TO: T10 Membership
FROM: Paul A. Suhler, Quantum Corporation
DATE: 3 March 2005
SUBJECT: T10/05-049r0, SSC-3 Physical Device Model

Figure X – Physical Device in SCSI Target Device

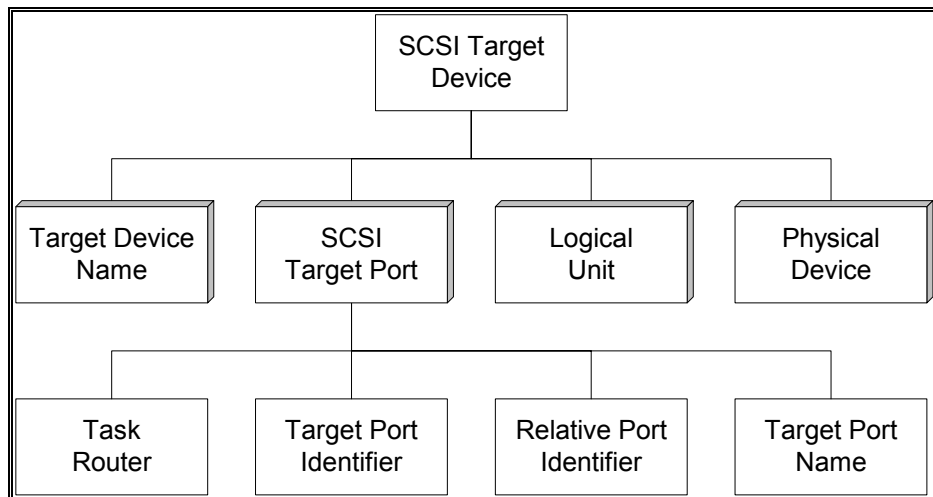
The following figure shows the location of the physical device in the SCSI target device model.

Editor’s Note: I chose SAM-3 Table 11 as the basis (rather than 14, Logical unit model) because multiple device servers can access the physical device. And I’ve shown multiple physical devices, even though I can’t name a tape drive that has them.
